# Annex 135C

## Chip-to-module 50 Gb/s 2-lane Attachment Unit Interface (LAUI-2 C2M)

Comment #121: Proposed changes to LAUI-2 C2M (similar changes to be applied to all C2M annexes)

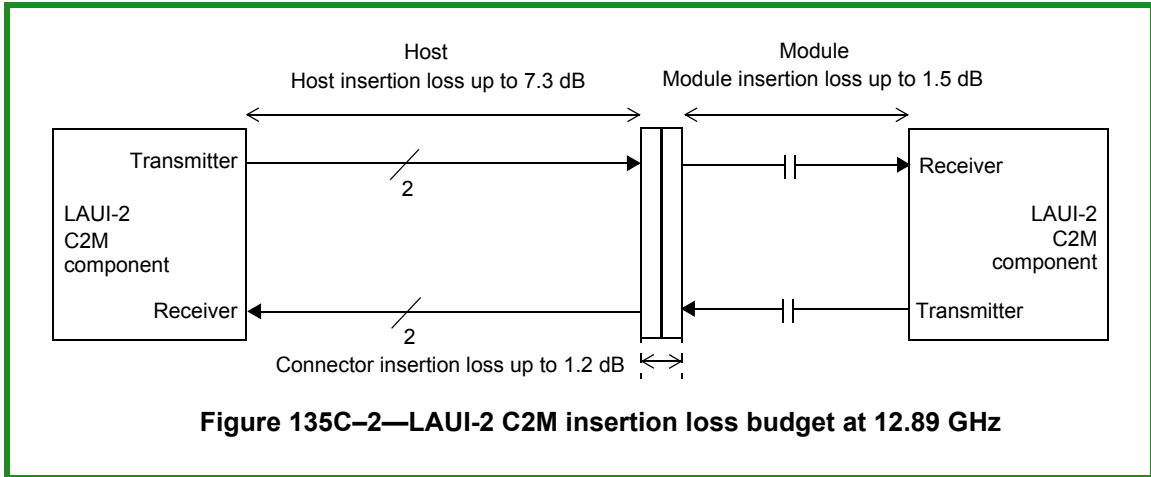
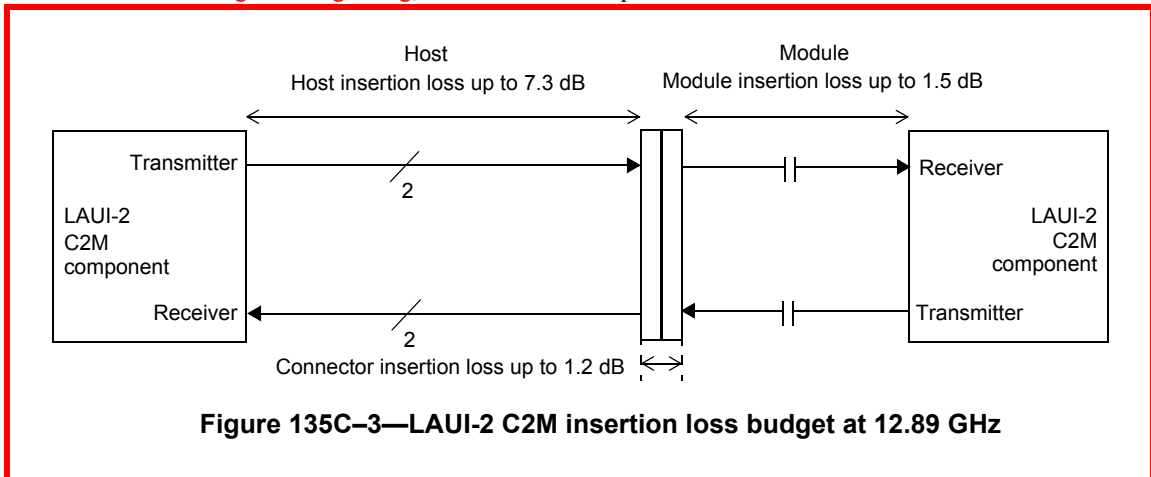
~~LAUI-2 C2M is a physical instantiation of the PMA service interface between the PCS and the FEC.~~

The LAUI-2 C2M link is described in terms of a host LAUI-2 C2M component, a LAUI-2 C2M channel with associated insertion loss, and a module LAUI-2 C2M component. Figure 135C-3 depicts a typical LAUI-2 C2M application and summarizes the differential insertion loss budget associated with the C2M

application. The supported insertion loss budget is characterized by Equation (83E-1) and illustrated in Figure 83E-3.-
